**TOWN OF MOUNTAIN VILLAGE
SPECIAL DESIGN REVIEW BOARD MEETING
AGENDA**

THURSDAY APRIL 22, 2021 10:00 AM

5.	10:15	30	Miller Applicant	Quasi-Judicial	Consideration of a Design Review: Final Architecture Review for a new Single-Family Detached Condominium residence on Lot 165, Unit 10, 200 Cortina Drive, pursuant to CDC section 17.4.11.

Roof MAX Height **2**

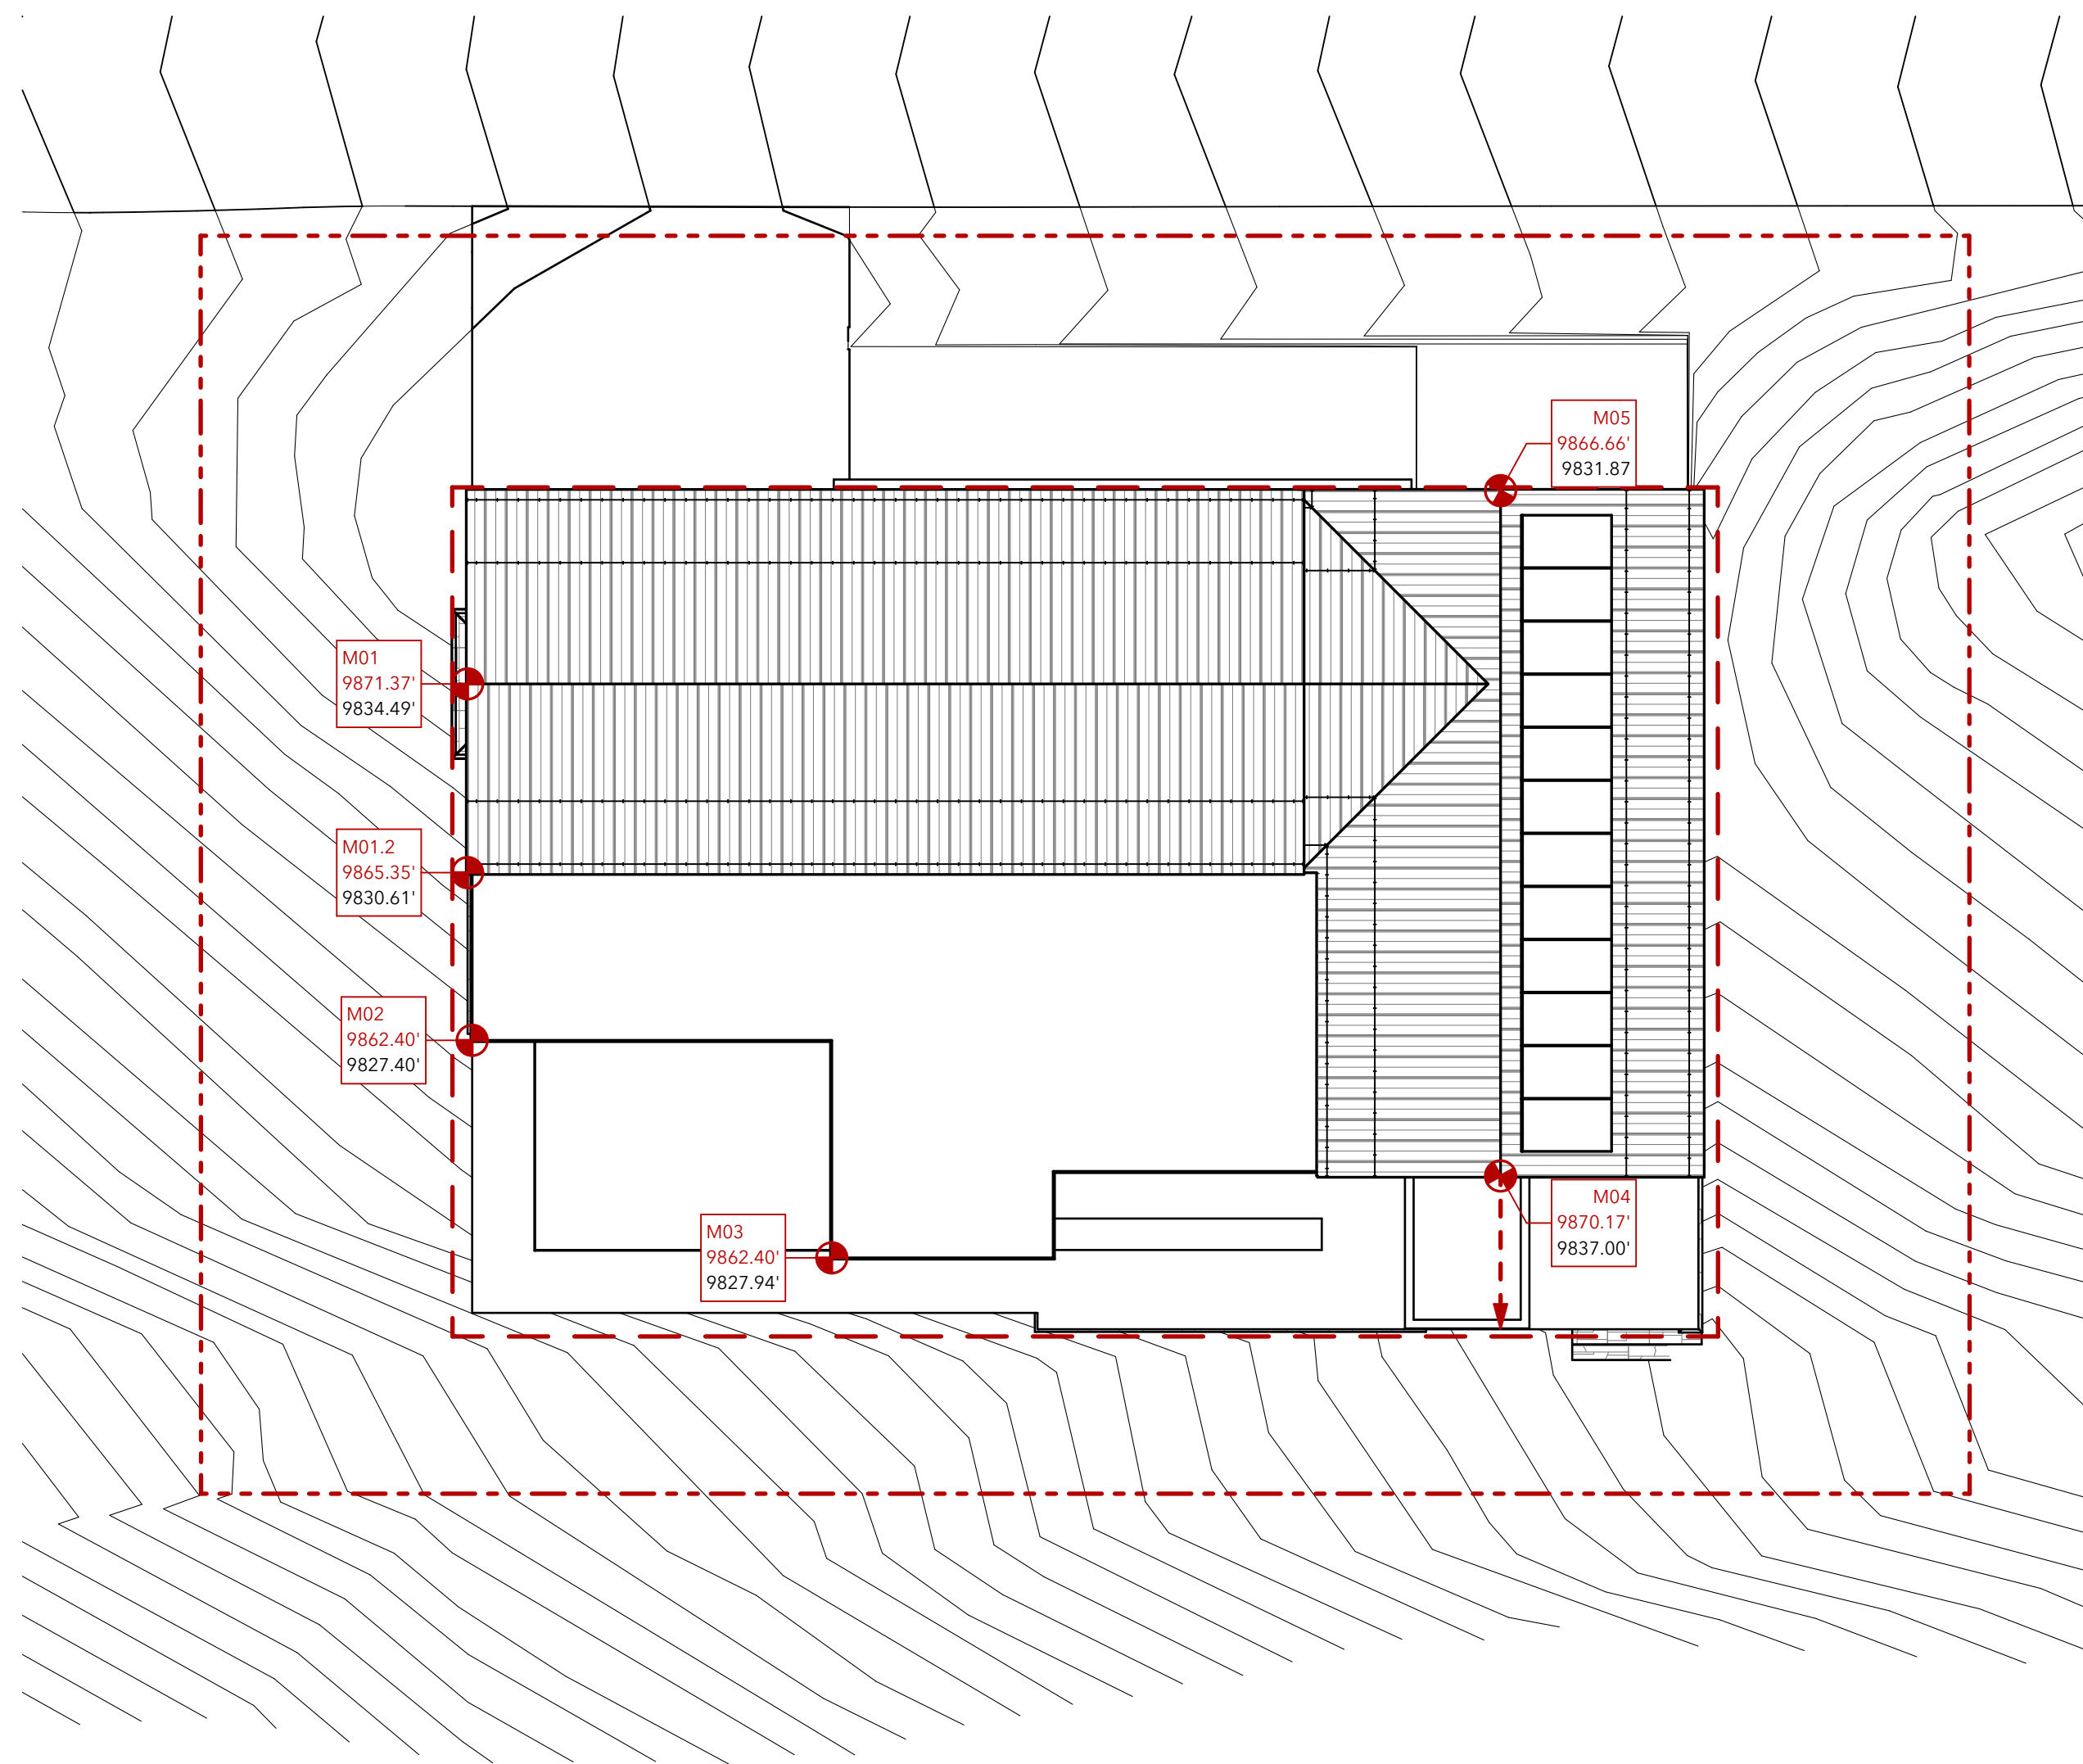
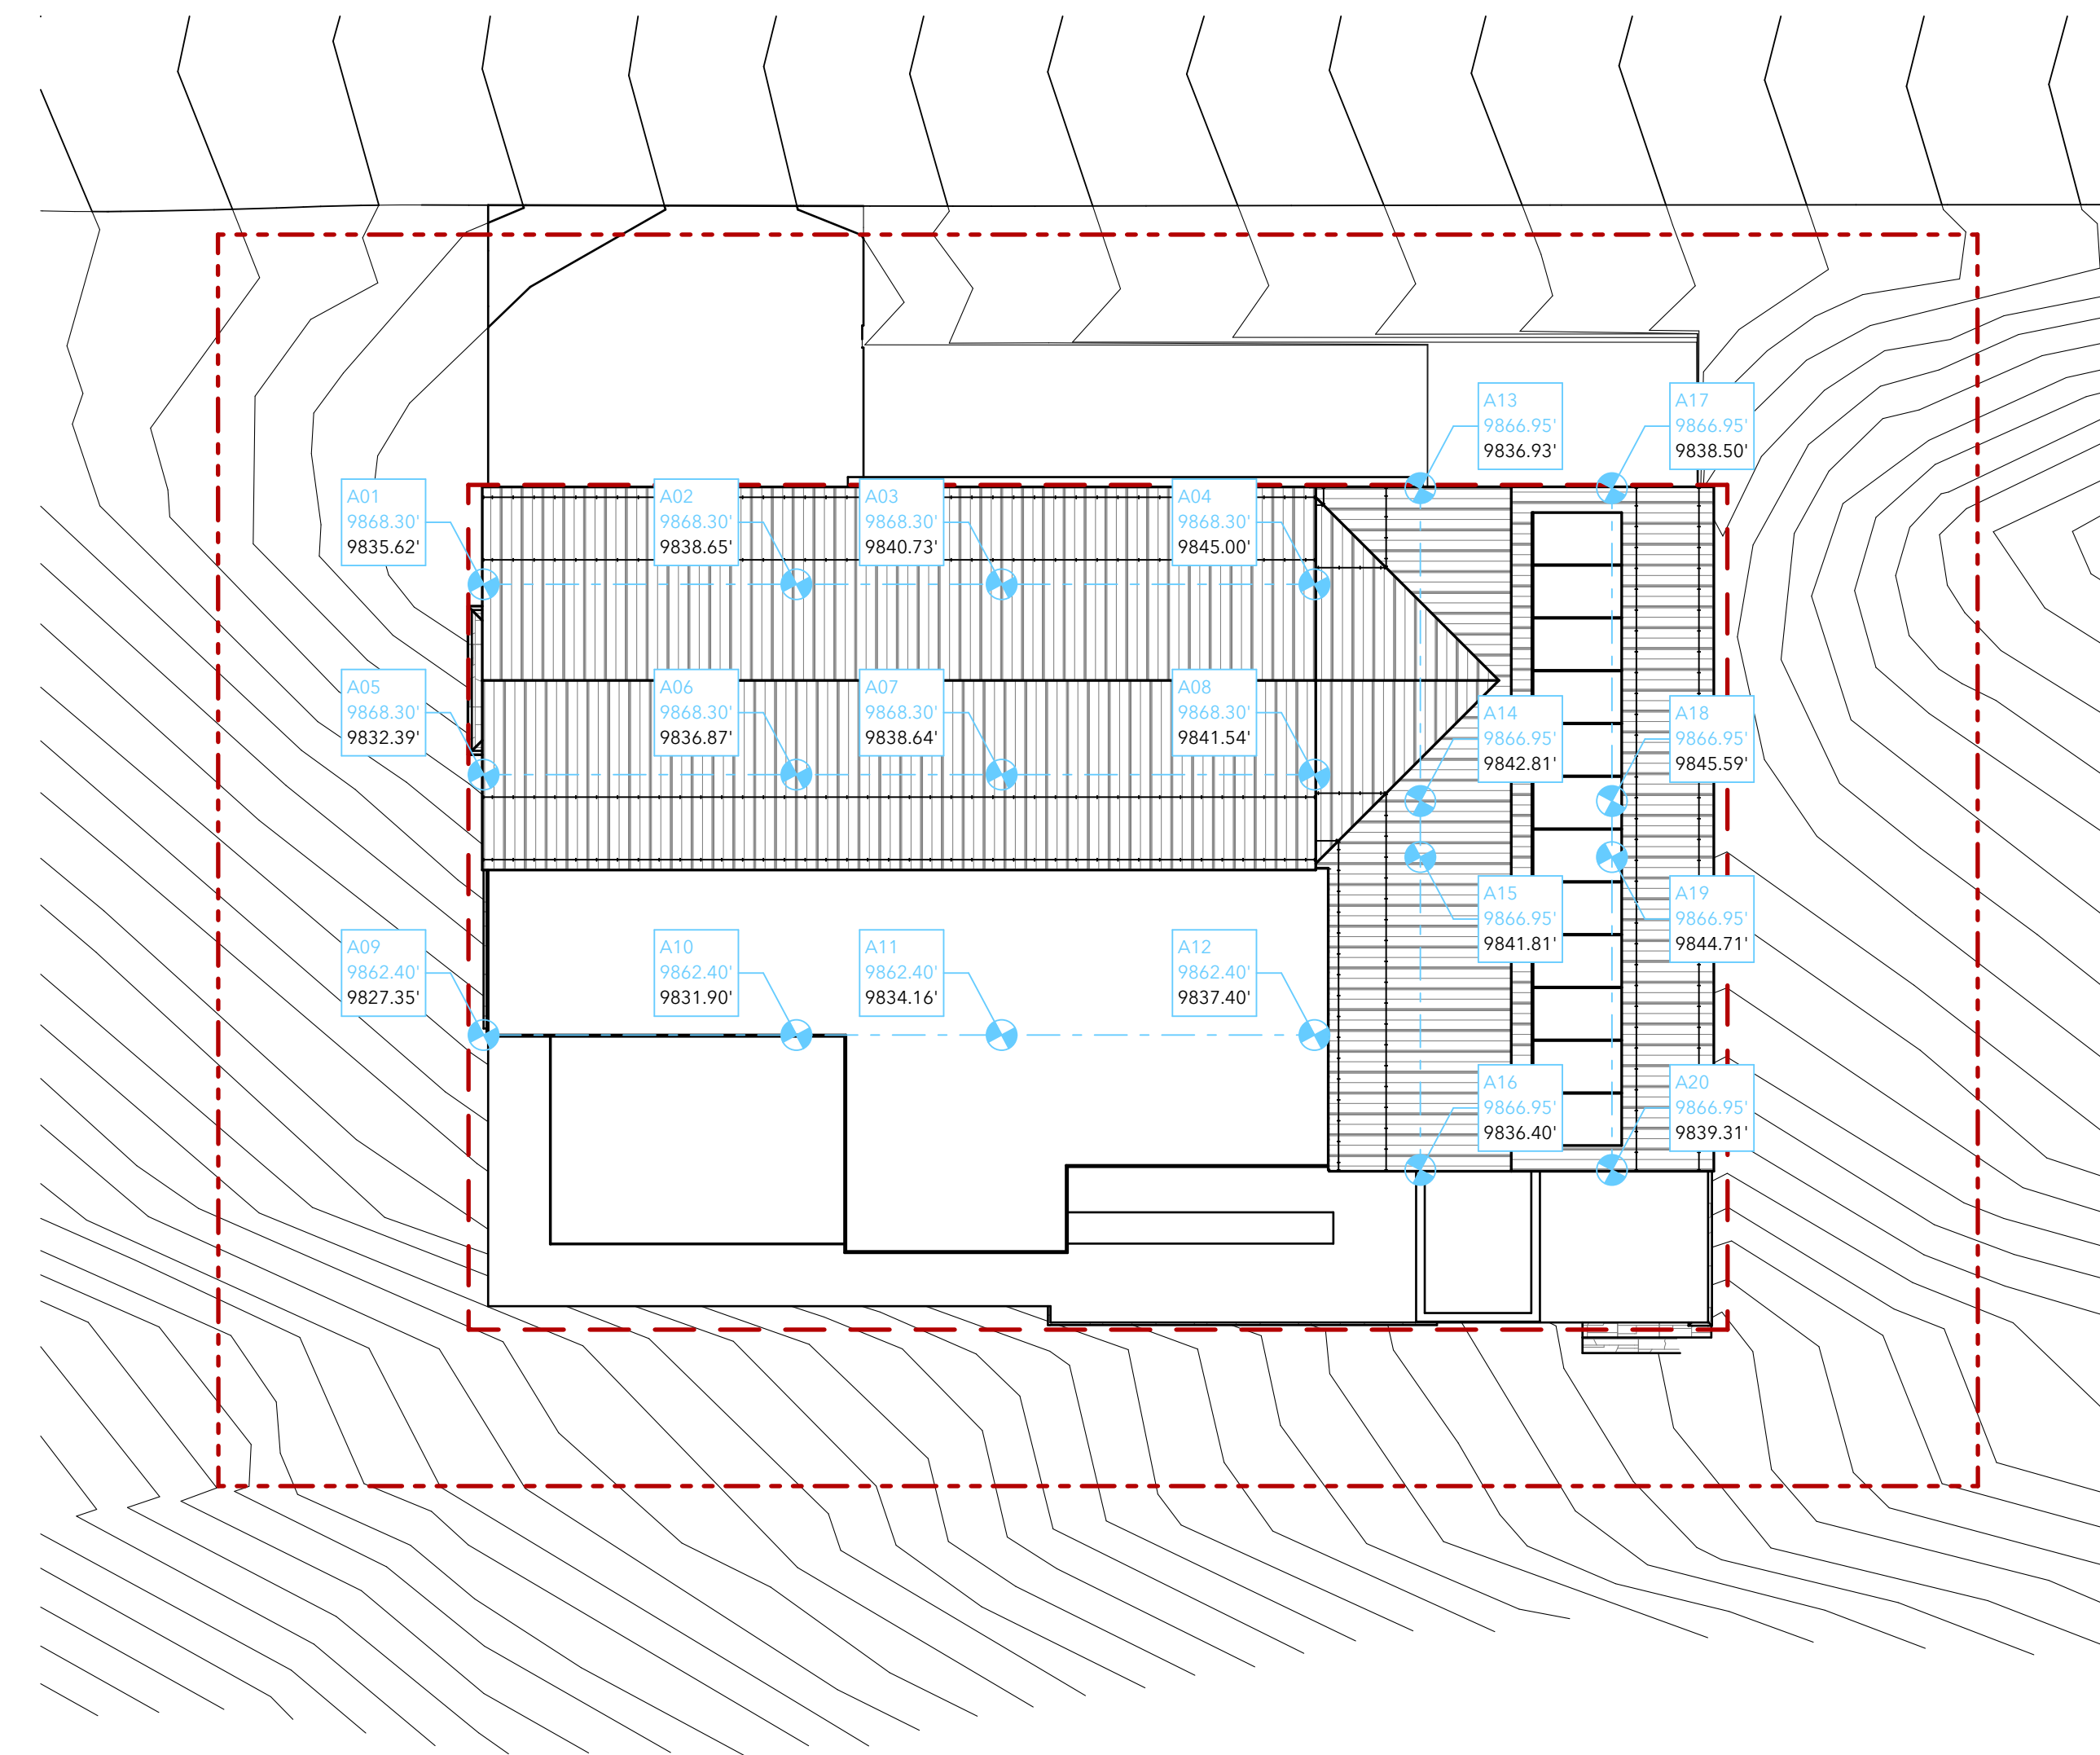
Staff: Based on the heights provided as part of the submittal documents, the maximum building height as proposed is 36.88 feet from the highest ridge to the grade below and the maximum average building height is shown at 28.26 feet. As part of the height analysis, the applicant has provided a parallel plane analysis demonstrating that no portion of the home penetrates the 40-foot parallel slope height allowance for gabled roof forms. The design does well in its incorporation of stepped massing as the topography of the site slopes down to the west. If the DRB concurs with the staff's height analysis, then there shall be a condition of approval that shall require a height survey to occur prior to framing inspections in order to demonstrate compliance with maximum heights.
